### **MANDATORY SERVICE BULLETIN**

Document No: 3286SC-02

Visual inspection of F. Atlee Dodge wing tank fuel sight gauges. Part No. 3286 in accordance with (IAW), STC SA02115AK.

STC SA02115AK, Document No. 3286IM, Drawing No. 3286.I.

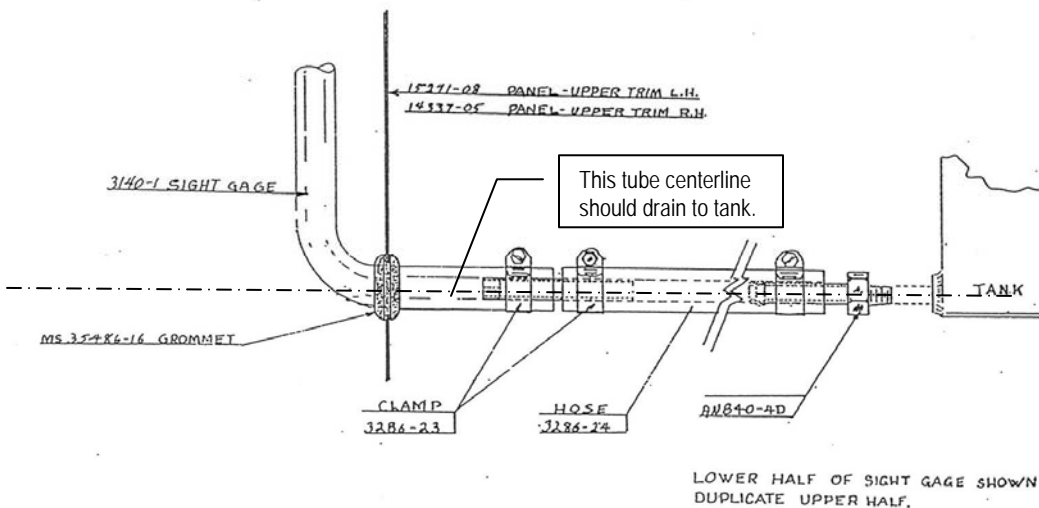
1. Verify the sight gauge fuel quantity calibration has been completed in accordance with (IAW) 3286IM. Marking in the A/C should be for both level flight and three point attitudes.
2. Verify that the lower half of sight gauge is installed with a horizontal or slight downward incline to tank.
3. Starting with at least a 1/2 full tank, fully drain the tank until empty. Examine and verify there is no residual fuel in the sight gauge. Verify the marking of Empty (step 1). If fuel is present when tank is empty, complete step two so the hose (3286-24) has a slight incline toward the tank (see illustration below). Repeat this step so that all fuel is draining into the tank.
